UMTRA PROJECT OFFICE
PROJECT INTERFACE DOCUMENT

Site Durango	Date 5/16/89	PID No. 03-S-18	Site No. 03	Y/c Pro No.
Originator and Location M. L. Wesely	Phone (415) 442-7517	Organization MKES	Answer By:	References: Subcontract: Subcontract No:
Subject

Additional Monitor Wells to Be Sealed

Site	Durango	Date	06/08/89	PID No.	03-S-17	Site No.	03	Vic Pro No.	
Originator and Location	M. L. Wesely	Phone	415 442-7517	Organization	MKES	Answer By:		References:	
Subject	Tailings Embankment Dewatering and Monitoring

FIGURE 0214E-C

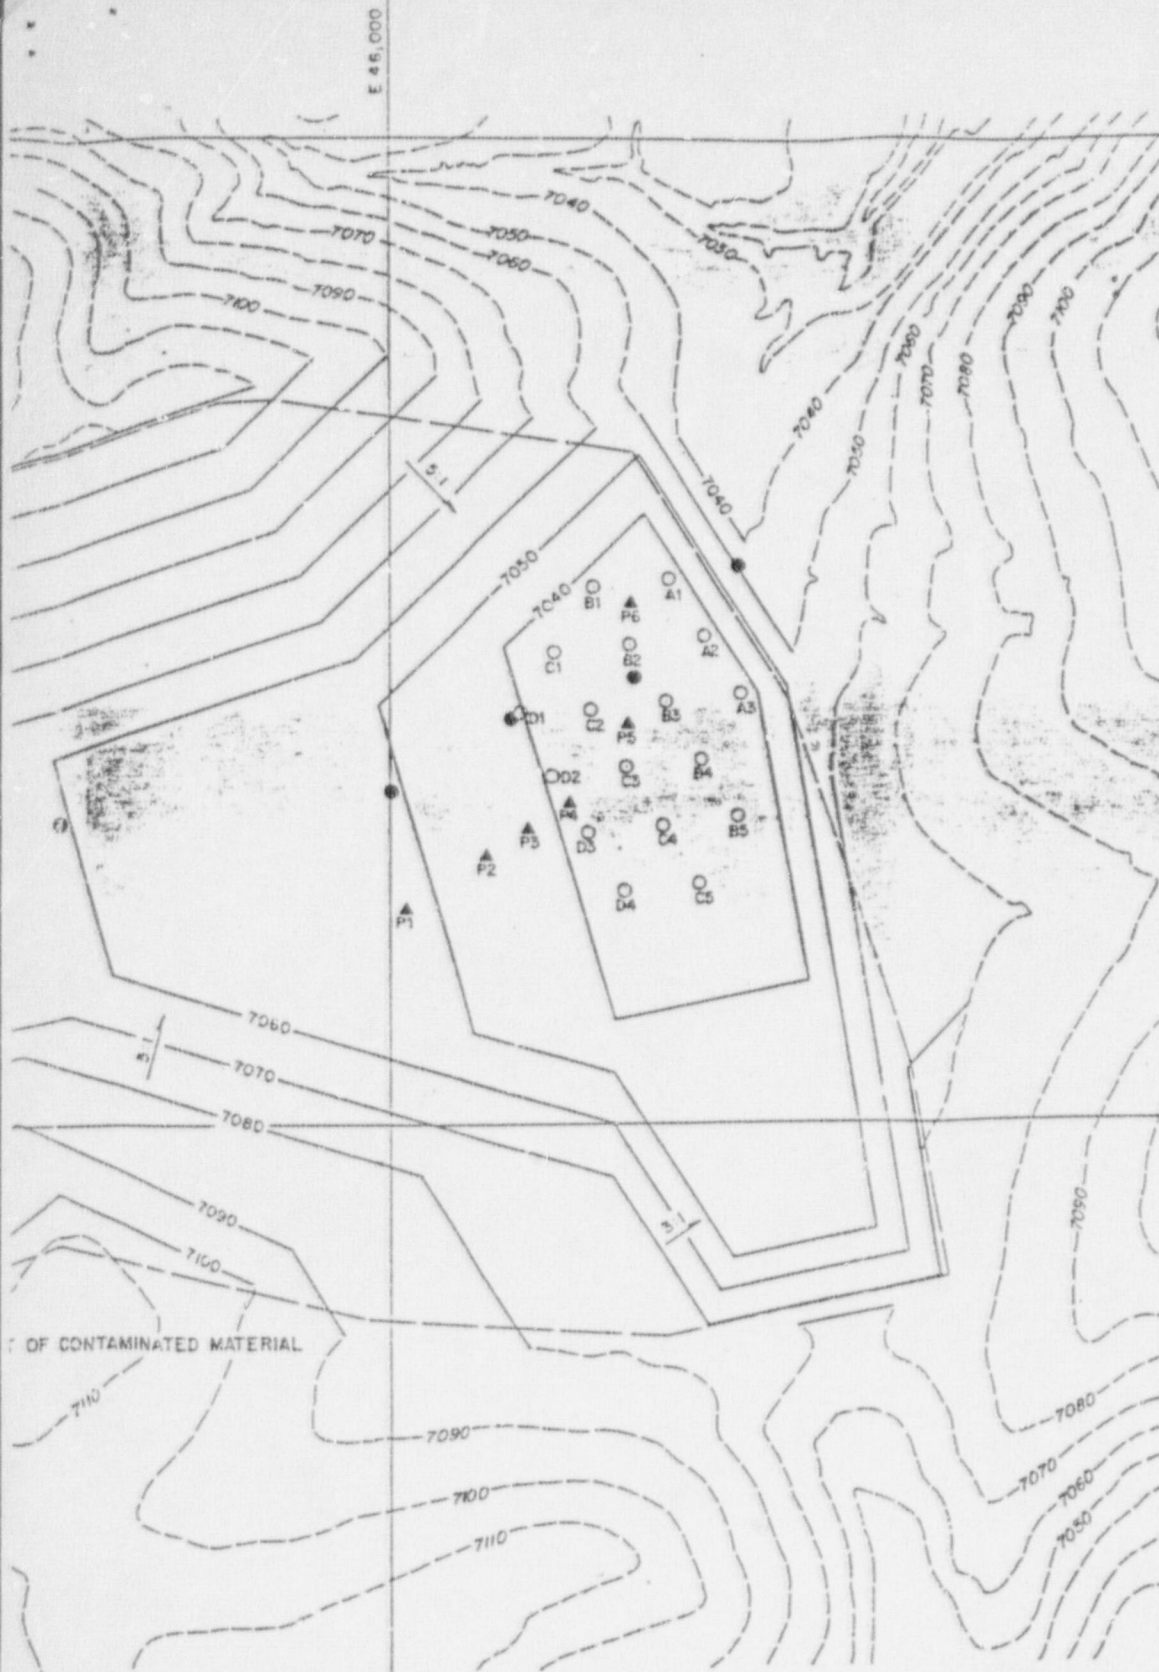
Problem: In October 1988, a seep developed on the lower eastern slope of the tailings disposal cell. Water taken from monitor wells installed in November 1988 showed elevated levels of contamination along with elevated levels of stored water within the cell.

Solution: A dewatering system of 17 wells will be installed to pump contaminated water from the disposal cell and to determine the feasibility of continued dewatering. The attached specification outlines the work to be performed.

- A. The Subcontractor shall install a complete dewatering system of seventeen wells as shown on Figure 02145-CC, complete with discharge lines, electrical distribution,
